Village of Arlington Heights
Plat and Subdivision Committee
Community Room, 3rd Floor
Arlington Heights Village Hall
33 S. Arlington Heights Road
Arlington Heights, IL 60005
March 9, 2016
6:30 PM

Item: Medical Office Building Expansion - 1100 W. Central Rd. - T1535

STAFF DEVELOPMENT COMMITTEE REPORT

To: Plat & Subdivision Committee
Prepared By: Bill Enright, Deputy Director Planning and Community Development
Meeting Date: March 9, 2016
Date Prepared: March 3, 2016
Project Title: Medical Office Expansion
Address: 1100 W Central Road

SITE PLAN Ambulatory Surgery Building
1/32" = 1'-0"

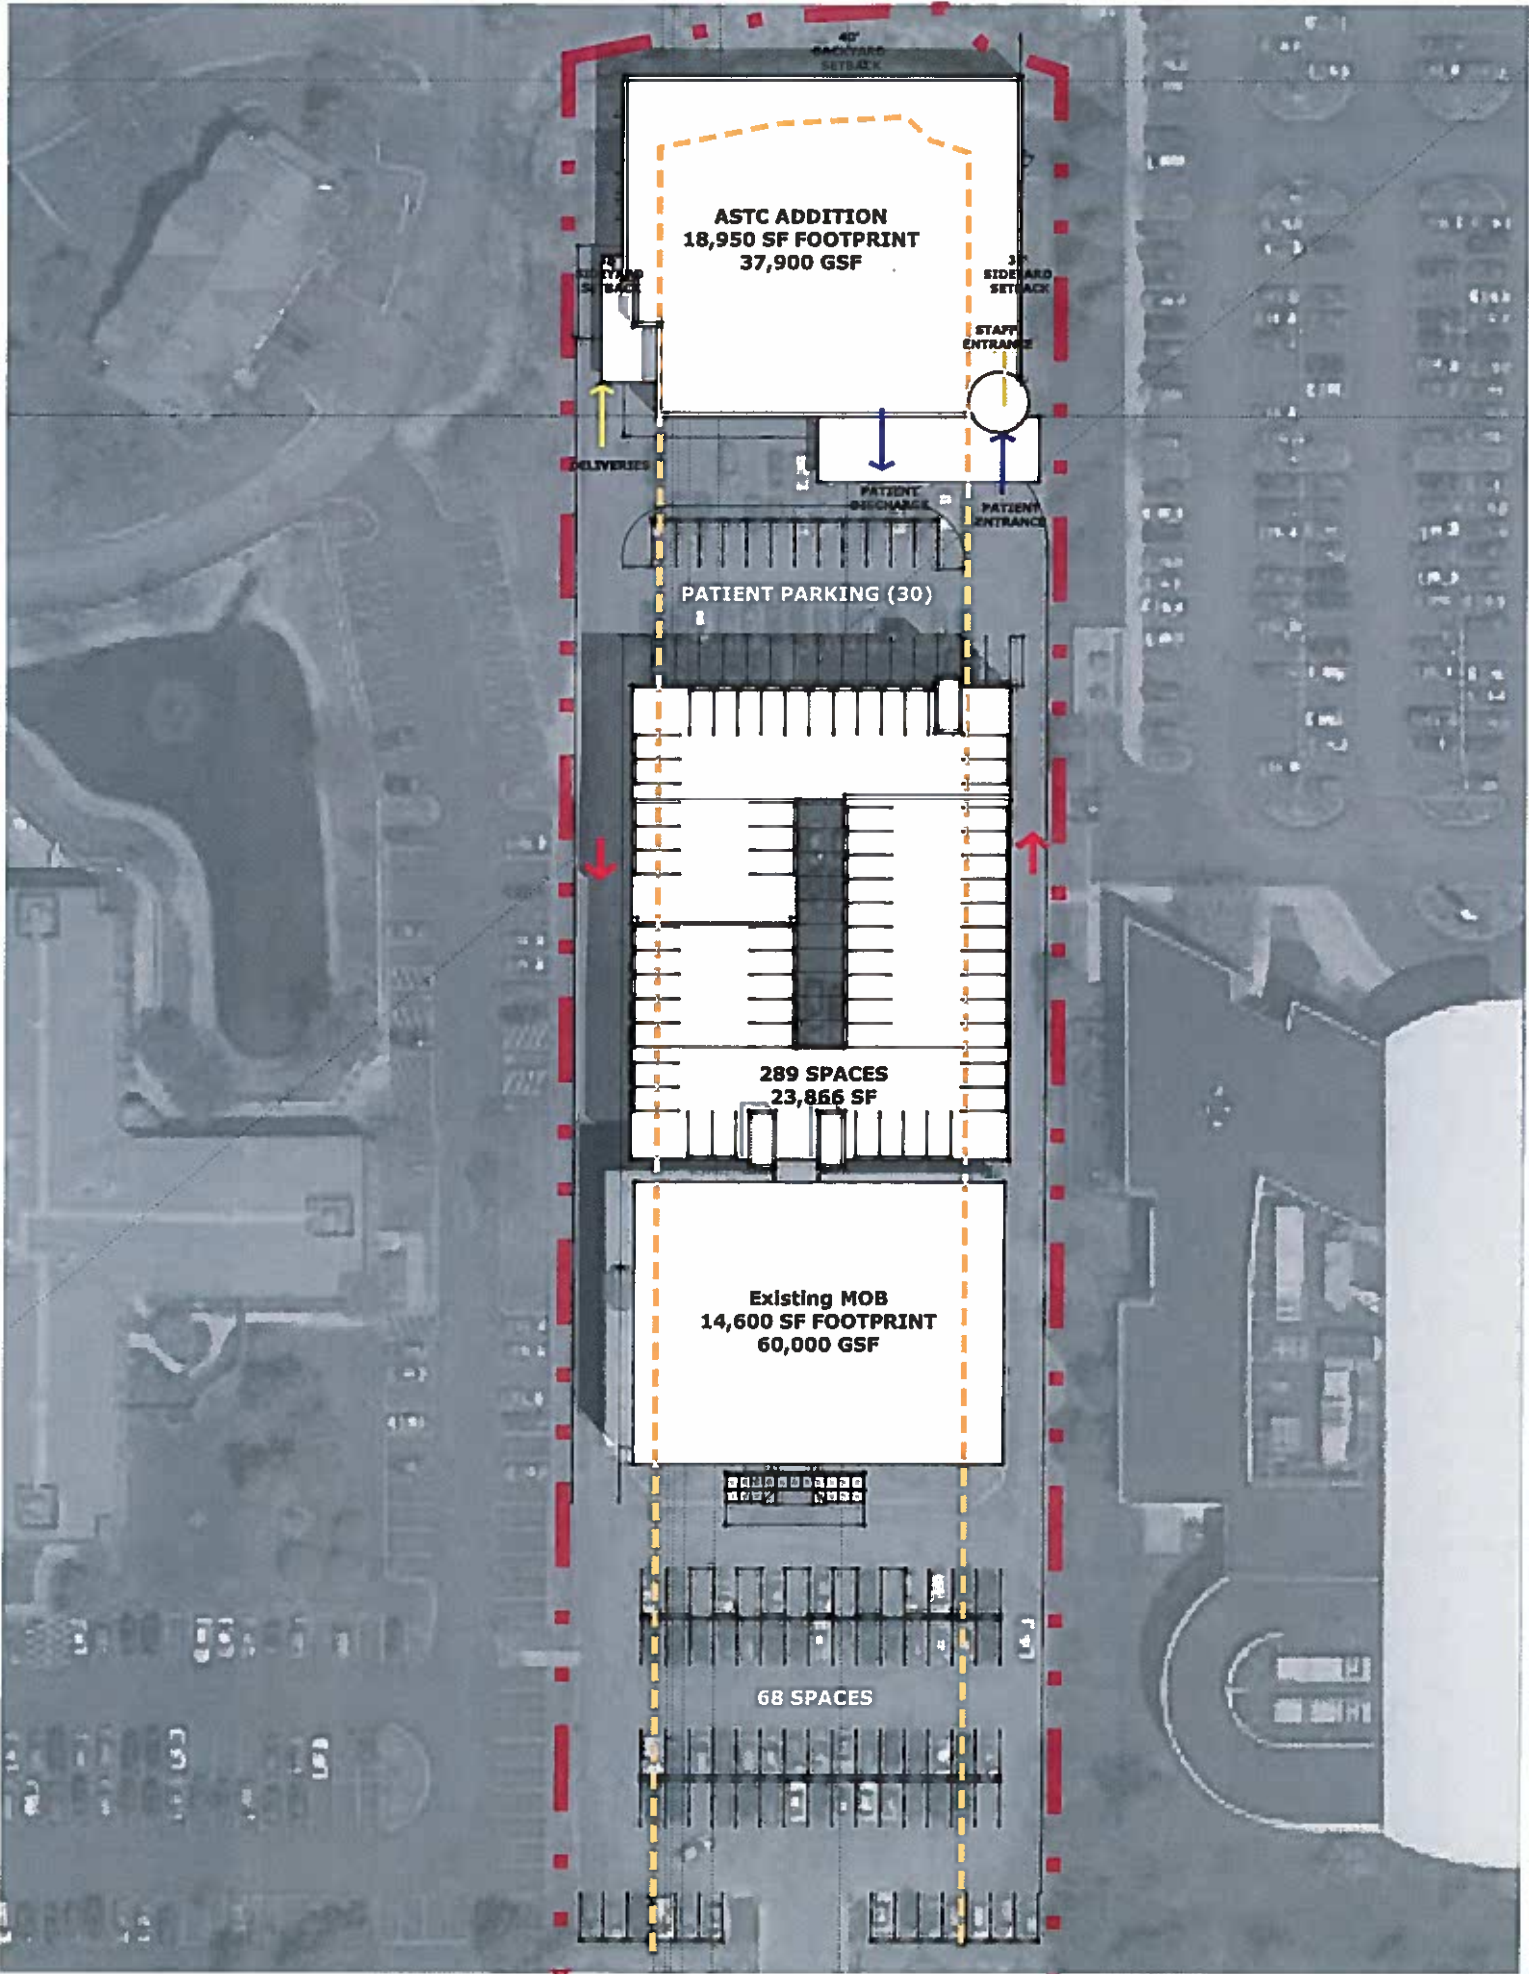
Preliminary Engineering plans shall be provided with calculations for storm water management in order to determine the extent of storm water management that will be required. On site detention shall be required meeting current standards. In addition, there are several landscape islands missing from parking rows which shall be required to be installed.

A traffic and parking study from a professional engineering firm shall be required. Issues to address include, but are not limited to: a parking analysis to demonstrate that there is adequate parking proposed, on site traffic circulation, and trip generation. Special attention shall be provided to the one access drive on Central Road given the expansion of floor area for the site. Staff has concerns with on site traffic flow and ingress and egress to / from the site. Also staff has concerns with the large parking deficit per code. Medical offices tend to have high peak demands therefore the parking portion of the study shall provide extensive detail and examples of parking required for the proposed uses, including existing parking counts for the office building currently on site. In addition, a secondary access point for emergency vehicles shall be provided, which can be limited to emergency access. Finally, Ordinance 72-045, which approved the current office building, required a cross access easement for the hospital to the east. It is not known if that easement was ever implemented and recorded. The petitioner shall provide a response to that requirement.

Use	Square Footage	Parking Ratio	Parking Required
Existing Medical Office	60,000	1 space / 200 square feet	300
Proposed New Building	30,000	1 space / 200 square feet	150
Total	90,000		450
Parking Provided			362
Surplus / (Deficit)			(88)
Loss of parking to comply with island requirement			14
Revised Surplus/(Deficit)			(102)

1. **Parking:** The existing building on the property is approximately 62,000 SF and with approximately 180 parking spaces provided. We are requesting that the parking ratio of 1/200 SF be only applied to the new construction. We plan to supplement the surface spaces with structured parking, and provide the additional Code required parking for the new building. We would retain the existing total amount of parking, plus provide 1/200 SF for the new building area (approximately 160 new spaces) arriving at the proposed total of 362.
2. **Storm Detention:** The proposed plan does not change the existing impervious area of the property as the current site is primarily asphalt for surface parking. Please clarify why this new plan would then require storm detention.
